PROPOSED CHANGE ORDER

PROJECT: Montgomery High School

PCO #: 25

DESCRIPTION OF THE PROPOSED CHANGE: Added Landscaping Project

G-004

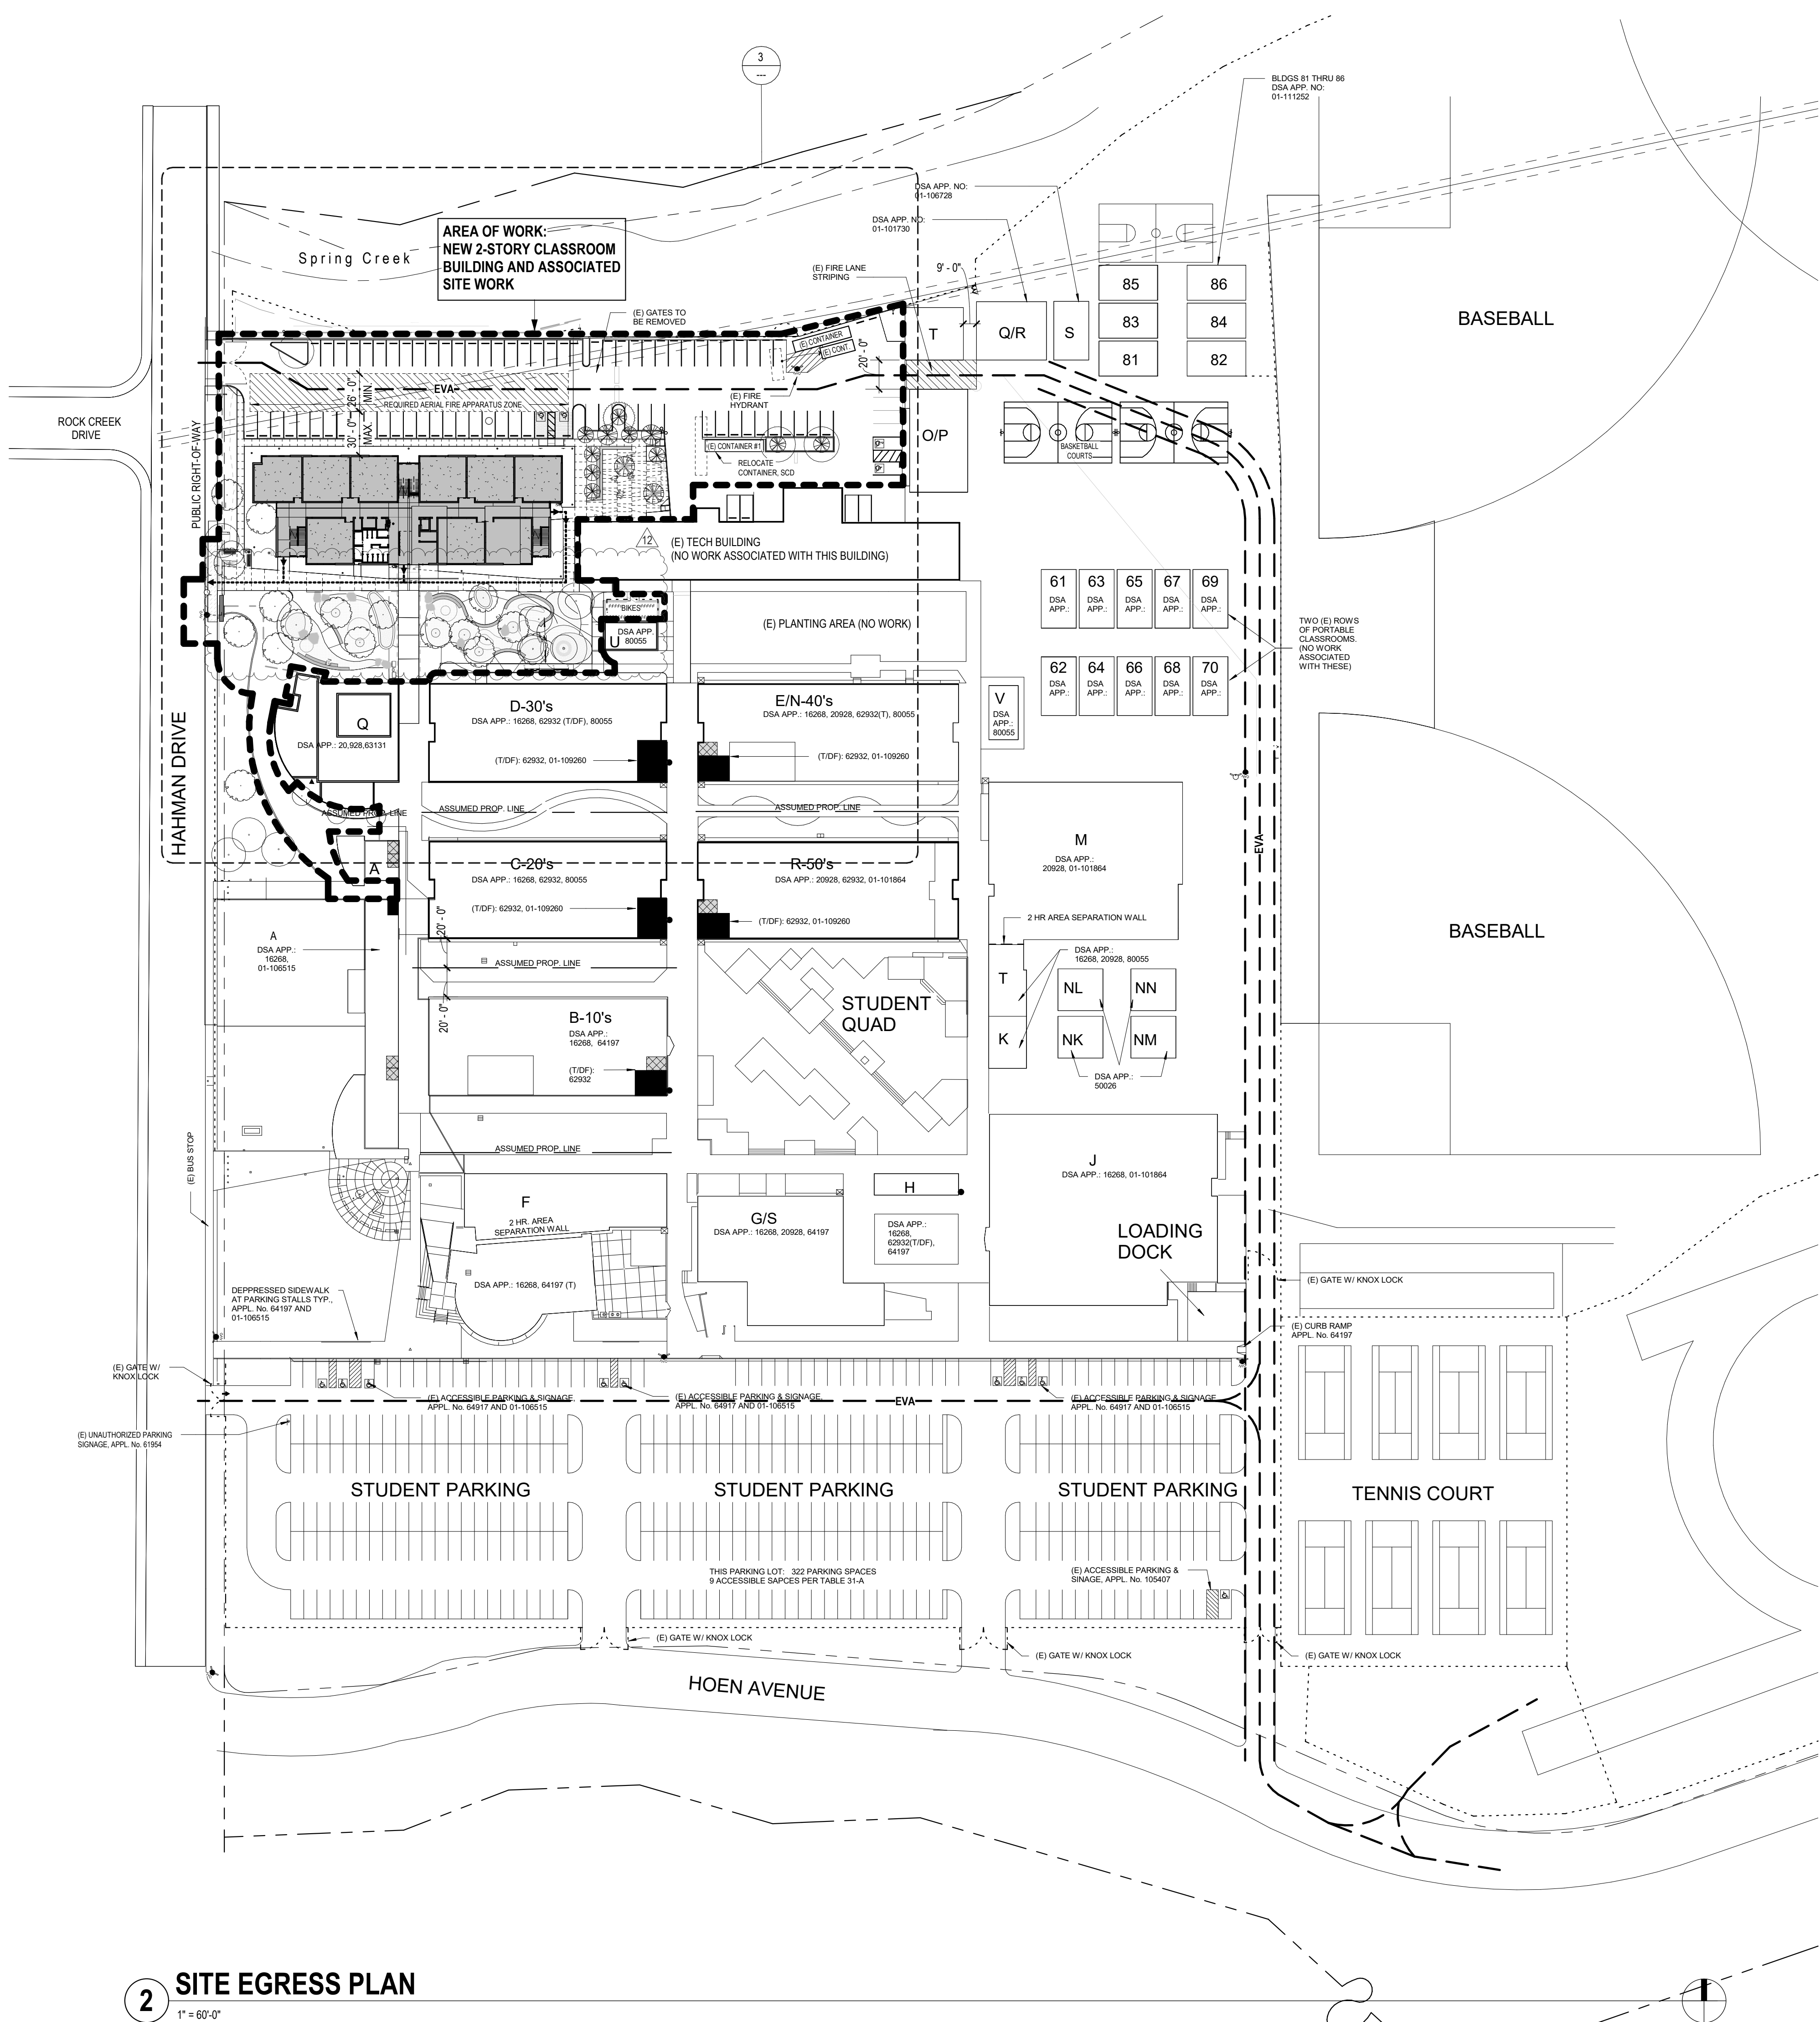
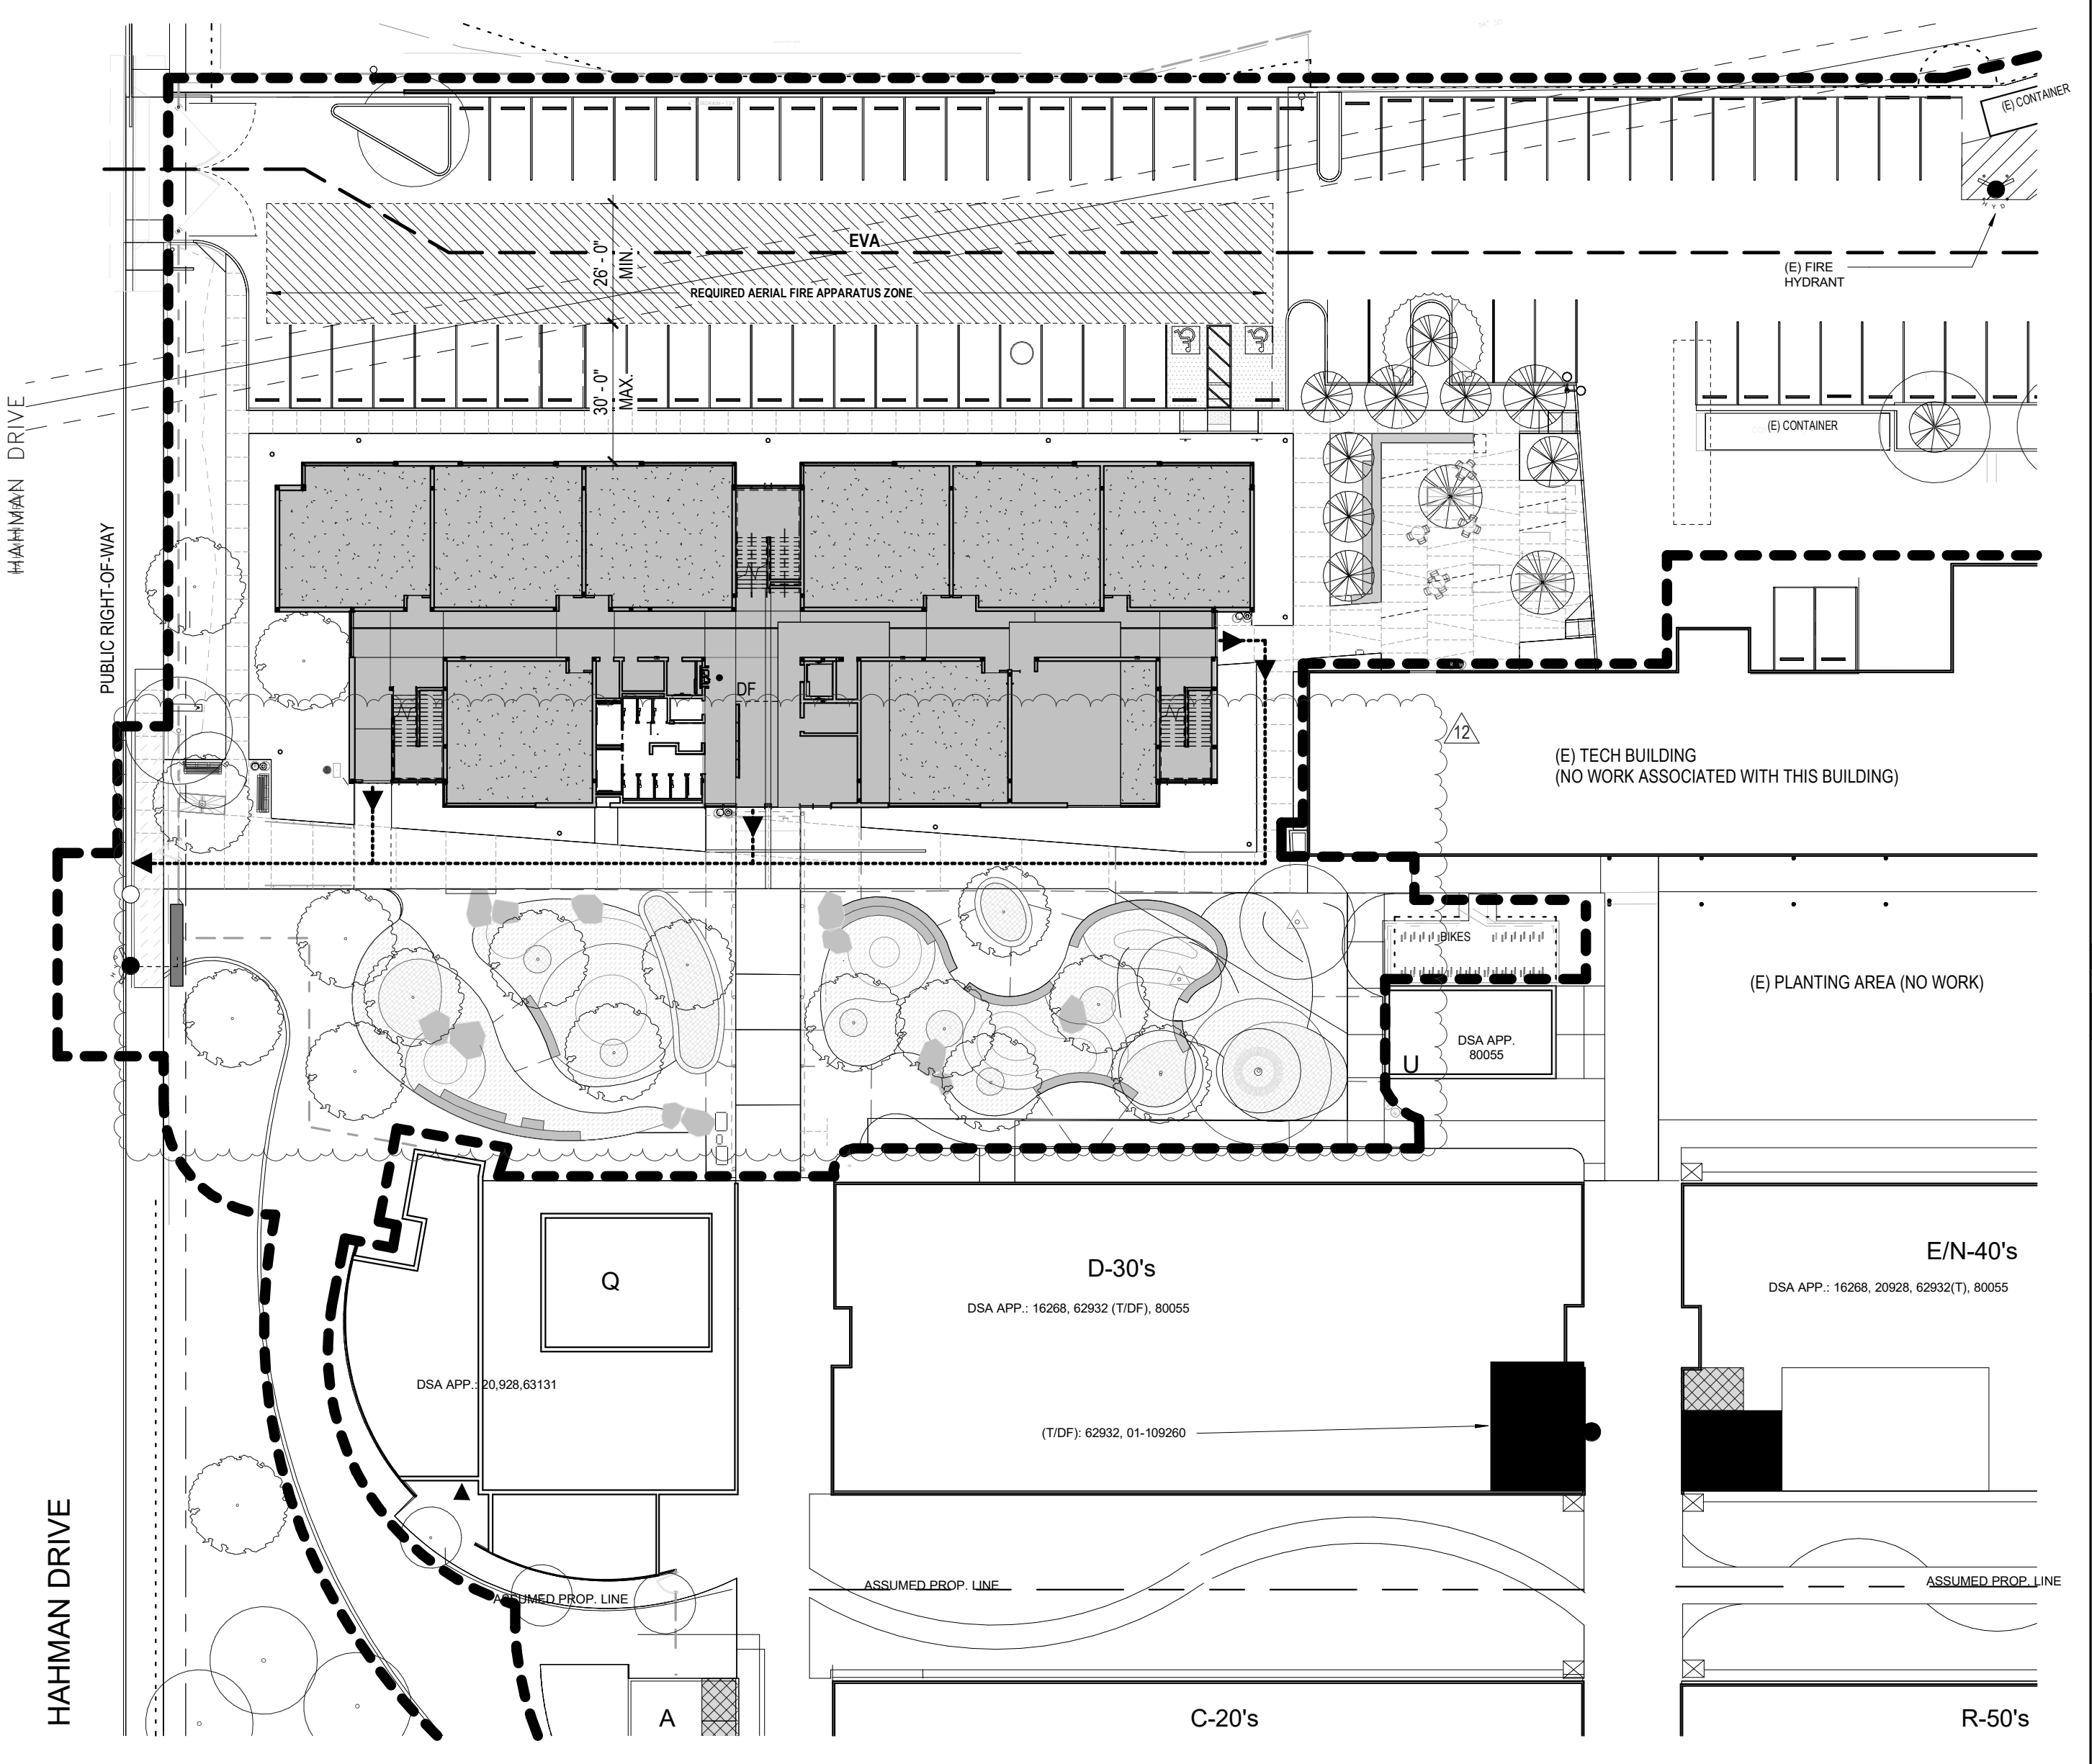
SHEET	CHANGE
G-004	Update egress site plan for new landscaped area
